MILITARY SPECIFICATION

EXPANSION JOINT, PIPE, NONMETALLIC, FIRE-RETARDANT

This amendment forms a part of Military Specification MIL-E-15330D(SH), dated 14 October 1977 and is approved for use by all Departments and Agencies of the Department of Defense.

FIGURE 1. Class A, type I, synthetic rubber expansion joint.

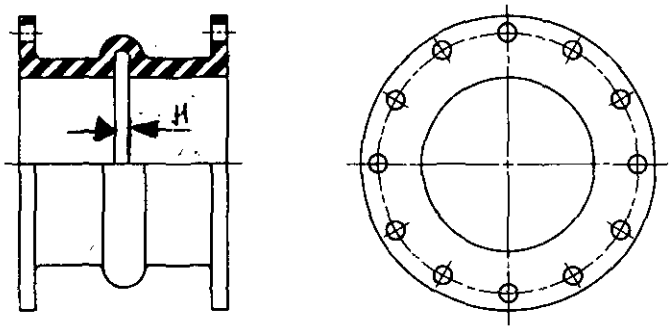
NOTE: The "H" dimension may vary from manufacturer to manufacturer. It is required marking data (see 3.4).
